IN THE MATTER of an application by Far North Solar
Farm Limited under section 42 of the
FTAA for the construction of The Point
Solar Farm in the Mackenzie Basin
ONL

APPLICATION NO. FTAA-2509-1100

**Planning Review Comments by Nick Boyes on behalf of
the Mackenzie District Council**

Dated: 19 February 2026

Figure 1: Mackenzie District Plan Natural Hazard Overlays (Source: Mackenzie District EPlan)

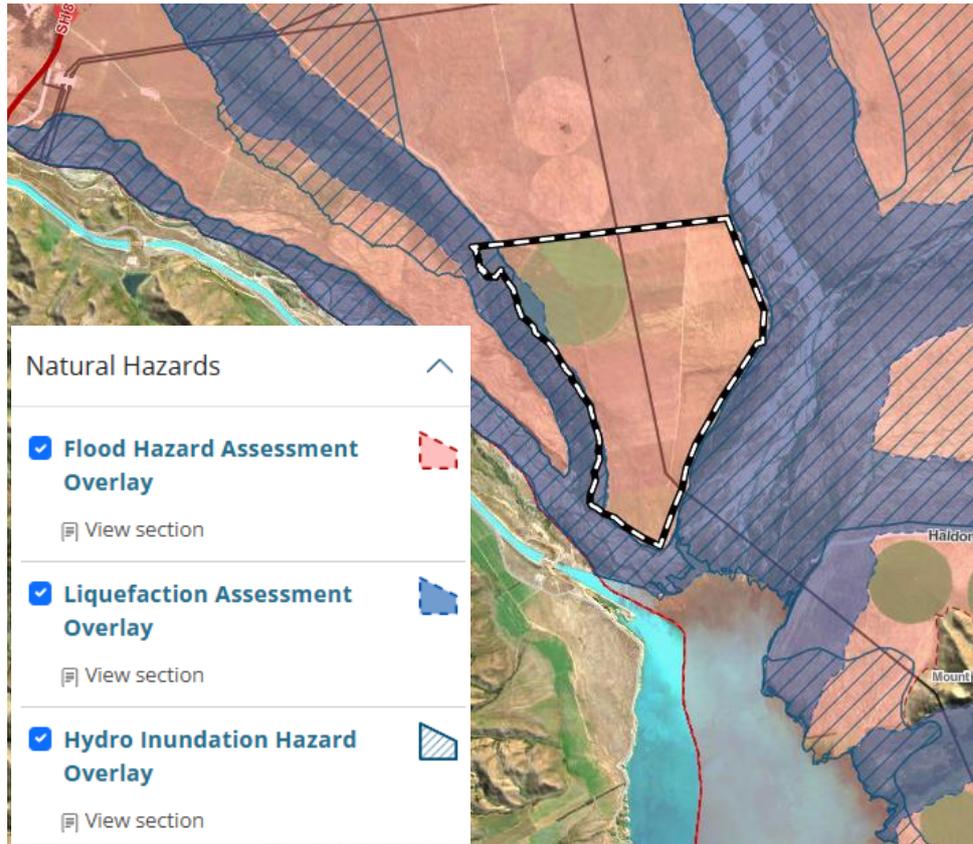
- 32 Despite being lodged after the notification of Stage 4 provisions (including PC28), the substantive application does not make any reference to either the Flood Hazard Assessment, Liquefaction Assessment, or Hydro Inundation Hazard District Plan Overlays. At section 3.1 of the updated substantive application the AEE states:

- 33 It is acknowledged this comment is made on the basis that the above Overlays for the most part immediately adjoin the site, and where they do impinge on the underlying site boundary, do not appear to include that part of the site on which the proposed solar arrays are to be located, as shown in **Figure 1** below.

- SUB-R7C 'Subdivision where any part of any proposed allotment is within the Liquefaction Assessment Overlay' (RDIS status). As shown in Figure 1 above, two small parts along the western boundary of the underlying site are within the Liquefaction Assessment Overlay. To retain RDIS status, the application must include a site-specific subsurface liquefaction assessment has been completed to at least a Level B assessment – 2017 MBIE/MFE Liquefaction Guidance (SUB-R7C.1). I am not aware on specific liquefaction assessment having been provided. Notwithstanding, any application not providing this information retains an RDIS status. Matters of discretion are restricted to:

- SUB-R7E 'Subdivision where any part of any proposed allotment is within the Hydro Inundation Hazard Overlay' (RDIS status). As shown in Figure 1 above, two small areas at the northern and southern ends of the western site boundary are within the Hydro Inundation Hazard Overlay. Matters of discretion are restricted to:
